**FURTHER REVISIONS TO
RESPONSES TO COMMENTS
for
9900 WILSHIRE PROJECT**

The City of Beverly Hills
Community Development Department (Planning Department)
455 North Rexford Drive, Room G-40
Beverly Hills, CA 90210

Impact Sciences, Inc.
234 East Colorado Boulevard, Suite 205
Pasadena, CA 91101

March 2008

Figure 4

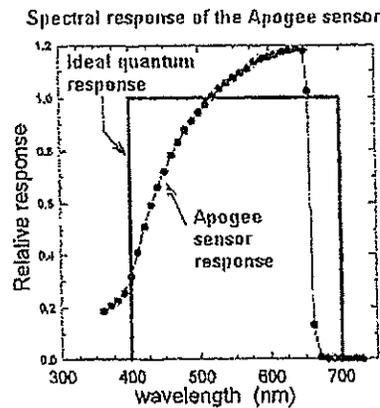
As their website states in the second paragraph, "The spectral response of the Sensor used in Quantum Meters and the Quantum Sensor is shown at right. As the figure indicates, the sensor underestimates the 400 to 500 nm wavelengths (blue light), overestimates the 550-650 wavelengths (yellow and orange light), and has little sensitivity above 650 nm (red light).

The peak light absorption for chlorophyll "a" as shown in Figure 2 is at 430 nanometers and again at 660 nanometers. The Quantum Light Meter underestimates light energy near the 430 peak area and misses the 660 peak altogether, as well as the critical far red light at 700 nanometers and up. The point is that the Quantum Light Meter is fine for what it was mostly intended: to measure and balance artificial light levels or under shade cloth in greenhouses and

As noted in Figure 4 of Mr. Hurdzan's letter, "common light sources are mixtures of colors and the spectral errors [of the QUANTUM meter] offset each other." This is because photosynthesis is driven by the *full spectrum of visible light* (generally, wavelengths between 400 and 700 nm), not *only* red or far red light as implied by Hurdzan (this is why green plants still grow indoors even when not exposed to direct sunlight).
